# THE CRANBROOK PLAN

Examination  
Hearing Statement – Additional Highway Detail / Sustainable  
Transport  
Questions AQ17 and AQ18

JBB8781  
The Cranbrook Plan

Appendix 1 Highways Costs Critique

Reference Plans (extracts from PSD24);

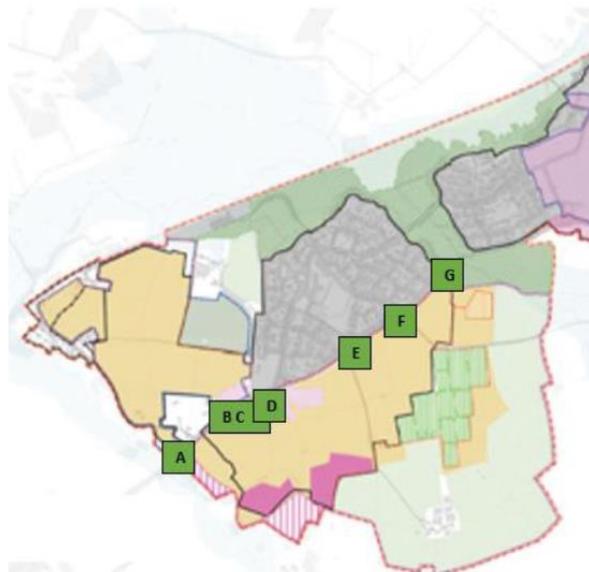
In summary, it's not possible to provide an accurate view on costs as scheme details are limited and haven't been agreed at this stage. With the information that is available and the proposals put forward, the total costs generally (in relation to typical junction forms) are considered to be broadly within the expected range (some costs are a little high or low). There are questions on the need for items C (Bridge between Treasbeare and Bluehayes) and item L (Roundabout Junction at Cobdens), the justification of which is set out in the main body of the Hearing Statement against AQ17.

Junction/Scheme (Junction ref as per those in PSD24)	Location	Description of Works	Proposed Costs	Vectos Review of Costs
A	Access for Bluehayes & Treasbeare	New cross roads	£625,000	Both items seem reasonable based on design as shown on 'Indicative Scheme Drawing' plan.
A	Access for Bluehayes & Treasbeare	Signalisation	£244,000	
B	Roundabout access to Bluehayes	New 3 arm roundabout	£1,832,000	Seems high for a 3-arm roundabout unsignalised, although there does appear to be level issues on the south side to deal with.
C	Bridge between Treasbeare & Bluehayes	New pedestrian bridge (items 5 and 6 in IDP)	£2,856,000	No comment, very much depends on the form/type of structure. Question it's need, better solutions via at-grade crossing at significantly lower cost.
D	Additional arm on existing roundabout for Treasbeare access	Enhanced existing roundabout with fourth arm added to serve Treasbeare expansion area	£163,000	On review of 'Indicative Scheme Drawing', this figure appears light considering the works to enlarge the existing roundabout.

D	Pedestrian Crossing	Pedestrian crossing facilities	£20,000	OK.
E	Toucan crossing between Treasbeare & existing Cranbrook	Pedestrian and cycle crossing point (provide a toucan crossing)	£149,000	Slightly high but OK.
F	Improvement of existing roundabout to provide access to Treasbeare	Enhancement to existing roundabout (4th arm to be enhanced)	£102,000	Appears Ok.
F	Improvement of existing roundabout to provide access to Treasbeare	Pedestrian crossing points	£82,000	OK.

G	Pelican crossing	Provide enhanced pedestrian crossing point as pelican crossing	£129,000	OK
H	Toucan crossing and closure of Gribble Lane	Gribble Lane closed to vehicular traffic and toucan crossing provided at this location to provide safe links to the sports hub located in Cobdens expansion area	£177,000	Slightly high but OK.
I	Access to Farlands	T junctions	£176,000	Appears OK.
J	Access to Cobdens and Grange	Low speed (20mph design standard) staggered cross roads	£625,000	Seems high, but very much depends on the traffic calming features that would need to be included (junction tables?).
K	Grange access	Provision of T junction to serve as secondary access to Grange	£176,000	Appears ok, depending on length of right turn lanes etc.
L	Cobdens roundabout access	New three arm roundabout to provide access to Cobdens lane and the Cobdens expansion area	£1,860,000	Seems high for a 3-arm roundabout unsignalised. Question whether this is needed. Potential for simple T-junction and incorporate with upgrading of London Road.

Road Closures – Station Road, Gribble Lane and Cobdens Lane	£82,000	OK.
		Upgrading of London Road between A and B	£353,000	OK.

Upgrading of London Road between I and L	£1,900,000	Much dependent on the design but appears high. Length is 560m so even if you rebuilt the road (assuming WS2) at £2,000 per linear metre (which is a high figure for this type of road) you would still only come out at £1.2m.
		London Road Service Diversions	£1,370,000	Unknown.
